BURLINGTON DEVELOPMENT REVIEW BOARD

Tuesday, May 16, 2023, 5:00 PM

1. ZAP-23-4; 71-73 Peru Street (RH, Ward 3C) Damon Lane

1. ZSP-23-3; 300 Flynn Avenue (NMU, Ward 5S) Howard Center for Human Services, Inc. / Joe Weith

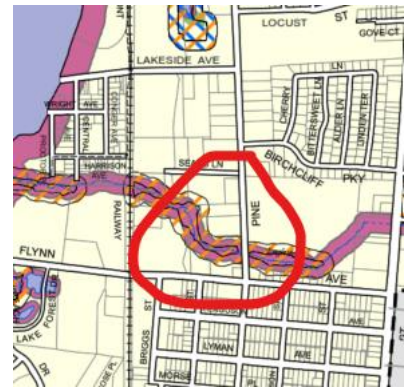
300 Flynn Avenue is within the:

1. ***Riparian and Littoral conservation Zone***, and
2. ***Wetland Conservation Zone***.

Reference is made to Plan C2.0, Site Grading and Layout Plan for the delineation; and the report of Gilman & Briggs Environmental.

(m) Landscaping and Fences:

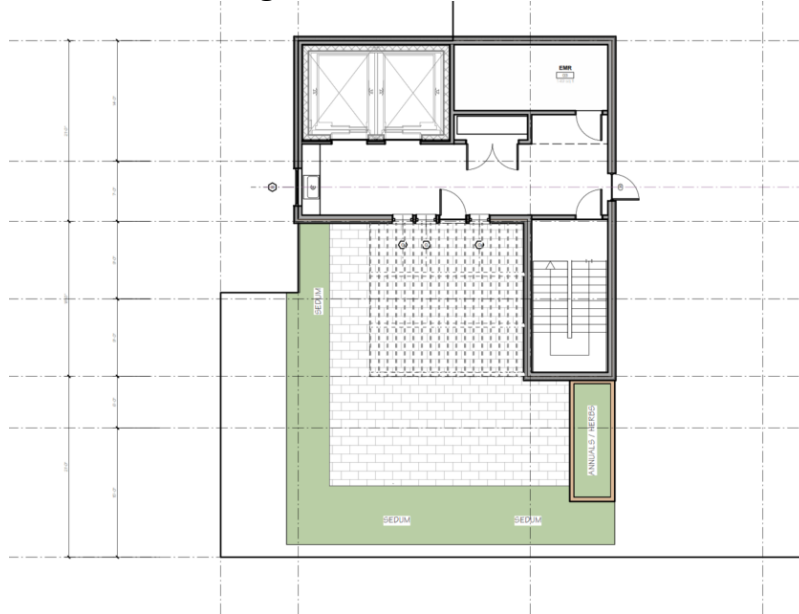
See Plan L1.0. Extensive landscaping is proposed for the south of the building, with additional tree planting to accommodate the parking lot shading requirement. The north/west of the site includes a concrete pad with fencing and a gate to enclose 2 dumpsters and recycling bins. (C8).

Affirmative finding.
